CUSTOMER : M/s. APTRANSCO	Design checked by	SCHEMATIC DIAGRAM 38 kV, 7.2 MVAR, 3 PH, CAPACITOR BANK	HITACHI ENERGY DRAWING NO.:	Rev	Scale	
					Drawing checked by			YC1H423188-002	0	NTS
					Drawn by				© Hitachi Energy	1
Rev	Revision	Appd	Year Week	Iss by Dept	Year Week	Cont.

Design checked by: VK	LAYOUT DRAWING OF 38 kV, 7.2 MVAR, 3 PH, CAPACITOR BANK	HITACHI ENERGY DRAWING NO.: YC1H423188-050
Drawing checked by: SK		
Drawn by: HKR

CUSTOMER : M/s APTRANSCO	Design checked by: VK	SUPPORT STRUCTURE FOR 38 kV, 7.2 MVAR	HITACHI ENERGY DRAWING NO.:	Rev	Scale
			Drawing checked by : SK	3 PH, CAPACITOR BANK & NCT.		00	NTS
			Drawn by : HKR		Iss by Dept PGHV-C		Sheet
					Year Week 24 06		1 OF 4
Rev	Revision	Appd	Year	Week	YC1H423188-080		Cont.
							2 OF 4

8534178/2024 SHEET ENDS  
This drawing is property of QUALITY POWER ELECTRICAL EQUIPMENTS PVT.LTD. It is submitted as confidential in connection with our enquiry/order. It is not to be used for any other purpose nor may it be copied or lent without our written permission.

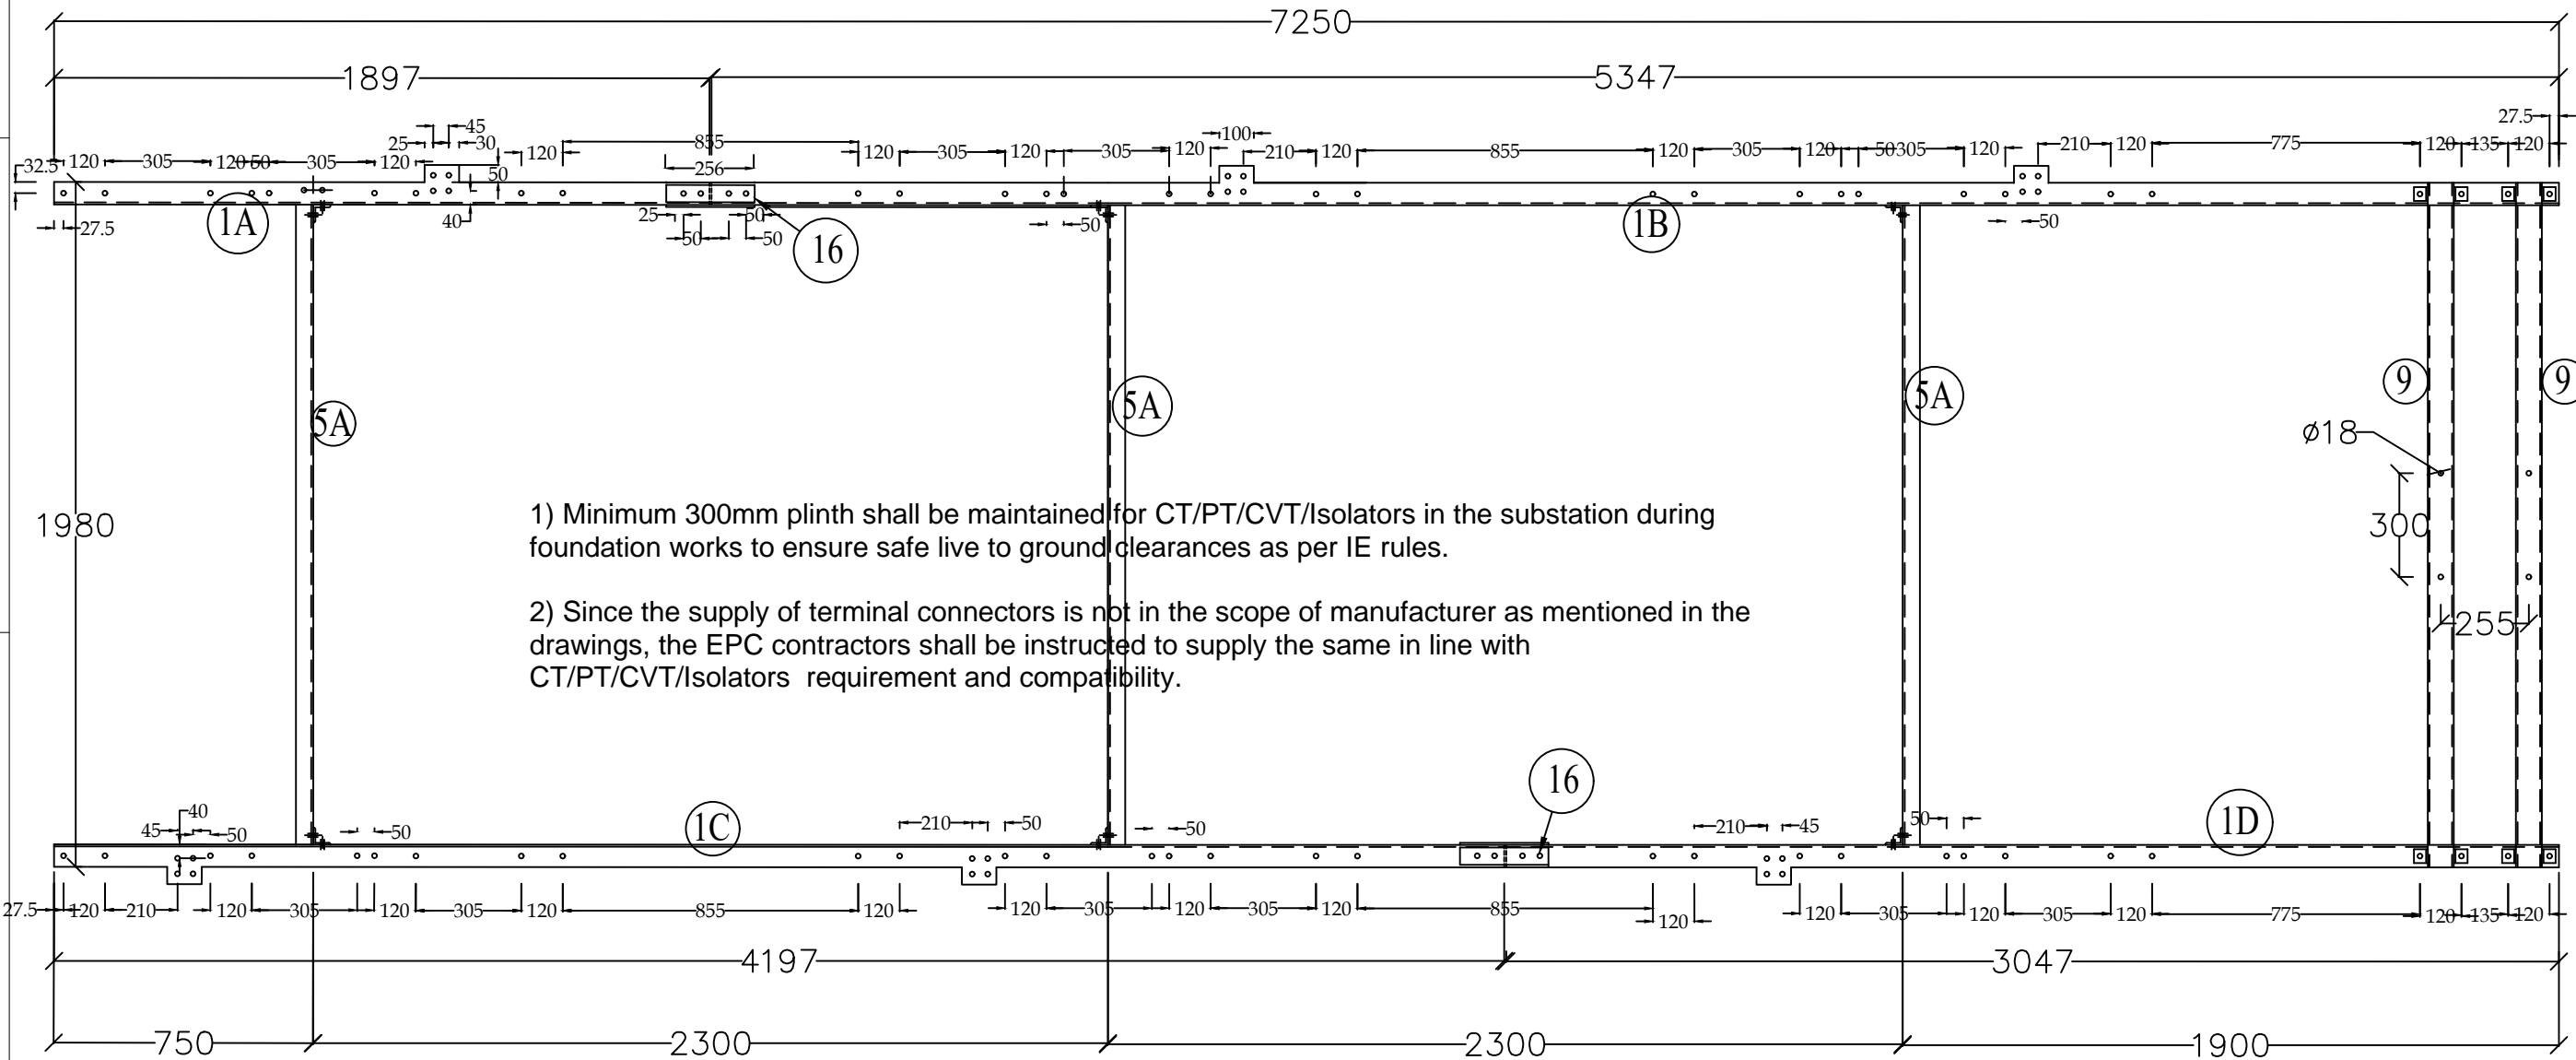
NOTE : DRAWING APPROVAL SUBJECT TO VALID TYPE TEST REPORTS.  
TO BE CHECKED DURING ACCEPTANCE TESTS.

- 1) Minimum 300mm plinth shall be maintained for CT/PT/CVT/Isolators in the substation during foundation works to ensure safe live to ground clearances as per IE rules.
- 2) Since the supply of terminal connectors is not in the scope of manufacturer as mentioned in the drawings, the EPC contractors shall be instructed to supply the same in line with CT/PT/CVT/Isolators requirement and compatibility.

NOTE : DRAWING APPROVAL SUBJECT TO VALID TYPE TEST REPORTS.  
TO BE CHECKED DURING ACCEPTANCE TESTS.

Drawing approval subject to valid vendor registration

CUSTOMER : M/s APTRANSCO				Design checked by: VK	CAPACITOR MOUNTING CHANNEL		HITACHI ENERGY DRAWING NO.:	Rev	Scale
				Drawing checked by : SK				00	NTS
				Drawn by : HKR			Iss by Dept Year Week PGHV-C 24 06		Sheet 1 OF 1
Rev	Revision	Appd	Year Week			YC1H423188-081			Cont. --

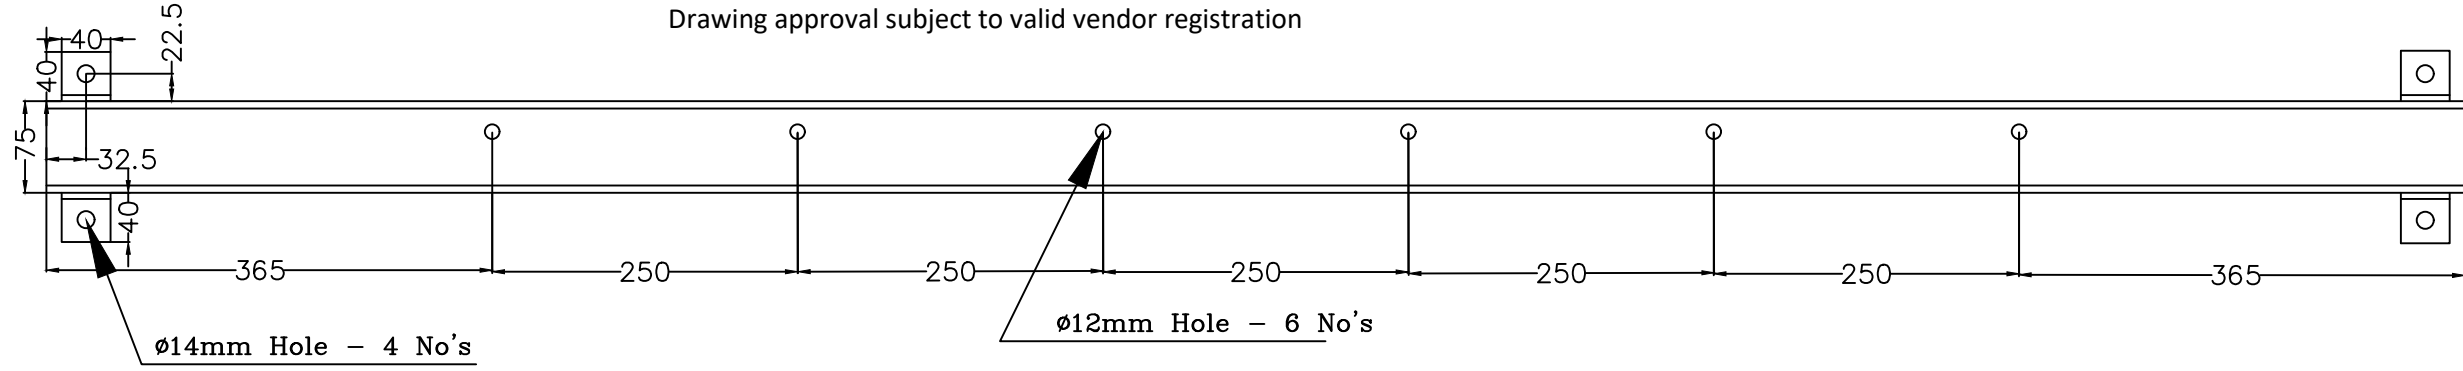
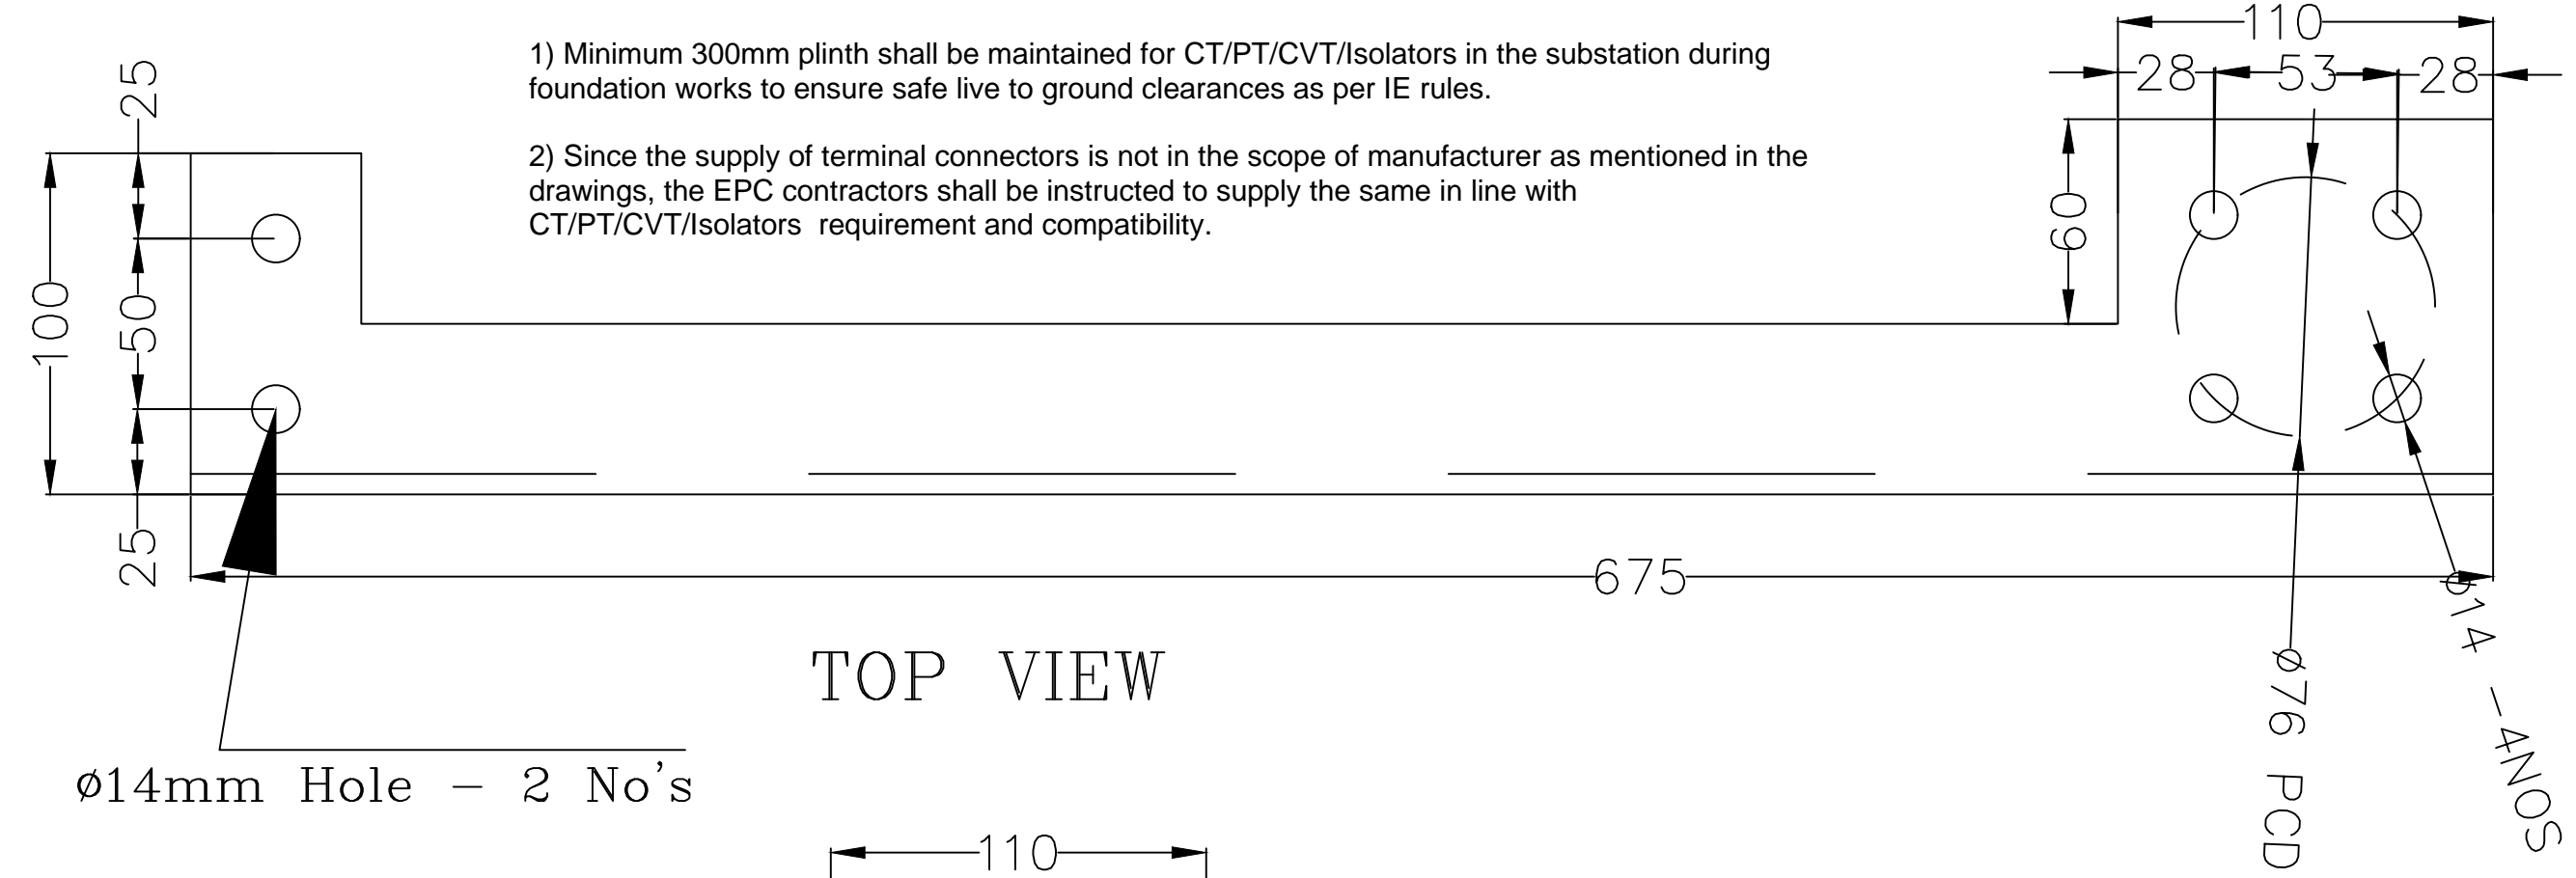
- 1) Minimum 300mm plinth shall be maintained for CT/PT/CVT/Isolators in the substation during foundation works to ensure safe live to ground clearances as per IE rules.
- 2) Since the supply of terminal connectors is not in the scope of manufacturer as mentioned in the drawings, the EPC contractors shall be instructed to supply the same in line with CT/PT/CVT/Isolators requirement and compatibility.

NOTE : DRAWING APPROVAL SUBJECT TO VALID TYPE TEST REPORTS.  
TO BE CHECKED DURING ACCEPTANCE TESTS.

CUSTOMER : M/s APTRANSCO			Design checked by: VK	RECATOR SUPPORT ANGEL RIGHT SIDE	HITACHI ENERGY DRAWING NO.:	Rev	Scale
			Drawing checked by : SK			00	NTS
			Drawn by : HKR	Hitachi Energy	Iss by Dept Year Week PGHV-C 24 06		Sheet 1 OF 1
Rev	Revision	Appd	Year	Week	YC1H423188-083		Cont. --

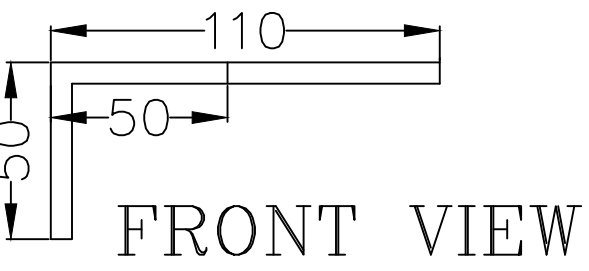
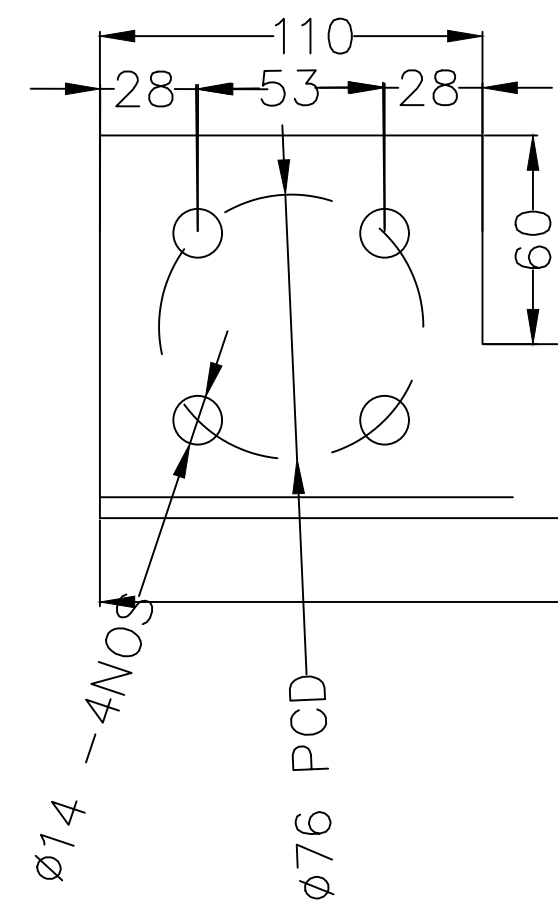
- 1) Minimum 300mm plinth shall be maintained for CT/PT/CVT/Isolators in the substation during foundation works to ensure safe live to ground clearances as per IE rules.
- 2) Since the supply of terminal connectors is not in the scope of manufacturer as mentioned in the drawings, the EPC contractors shall be instructed to supply the same in line with CT/PT/CVT/Isolators requirement and compatibility.

NOTE : DRAWING APPROVAL SUBJECT TO VALID TYPE TEST REPORTS.  
TO BE CHECKED DURING ACCEPTANCE TESTS.

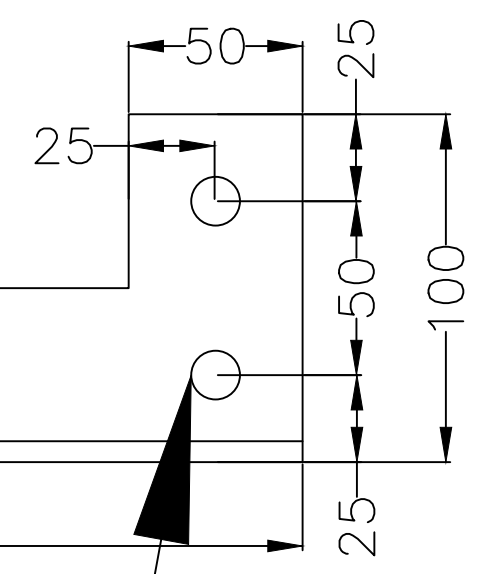
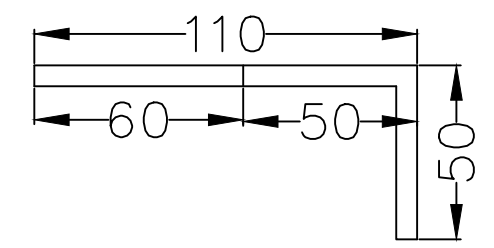
- 1) Minimum 300mm plinth shall be maintained for CT/PT/CVT/Isolators in the substation during foundation works to ensure safe live to ground clearances as per IE rules.
- 2) Since the supply of terminal connectors is not in the scope of manufacturer as mentioned in the drawings, the EPC contractors shall be instructed to supply the same in line with CT/PT/CVT/Isolators requirement and compatibility.

NOTE : DRAWING APPROVAL SUBJECT TO VALID TYPE TEST REPORTS.  
TO BE CHECKED DURING ACCEPTANCE TESTS.

TITLE :- GENERAL ASSEMBLY DRAWING OF 33kV, 54.7A, 0.802 Ω SERIES REACTOR

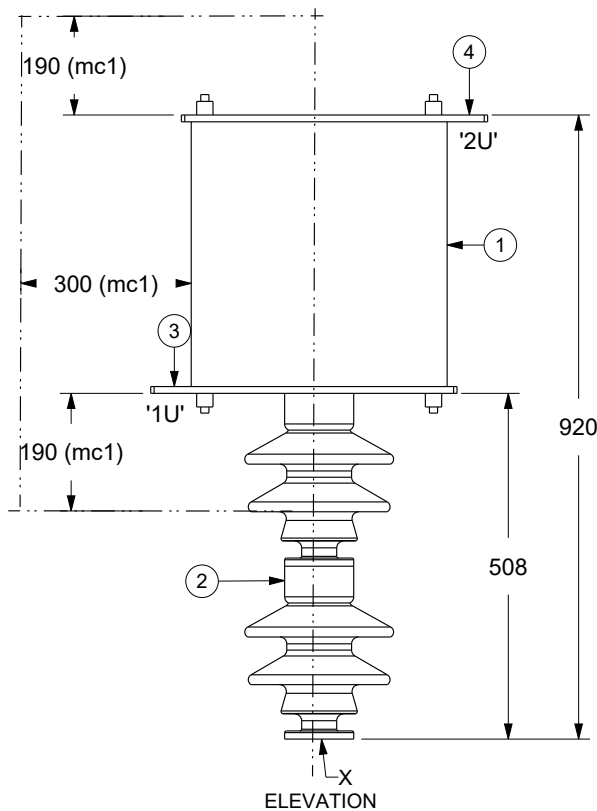
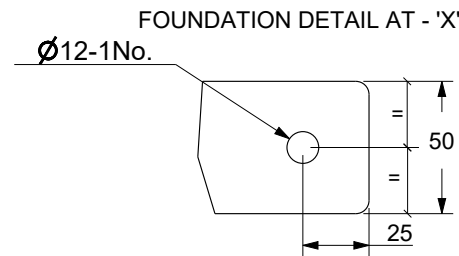
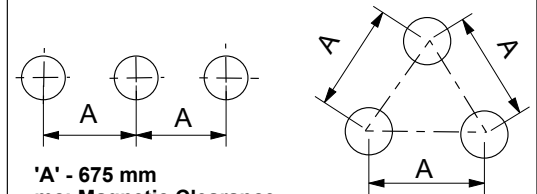
NOTE : DRAWING APPROVAL SUBJECT TO VALID TYPE TEST REPORTS.

TO BE CHECKED DURING ACCEPTANCE TESTS.

of terminal connectors is not in the scope of manufacturer as mentioned in the drawings, the EPC contractors shall be instructed to supply the same in line with CT/IVT/CVT requirement and compatibility.

TO BE CHECKED DURING ACCEPTANCE TESTS.

1) Minimum 300mm plinth shall be maintained for CT/PT/CVT/Isolators in the substation during foundation works to ensure safe live to ground clearances as per IE rules.

2) Since the supply of terminal connectors is not in the scope of manufacturer as mentioned in the drawings, the EPC contractors shall be instructed to supply the same in line with CT/PT/CVT/Isolators requirement and compatibility.
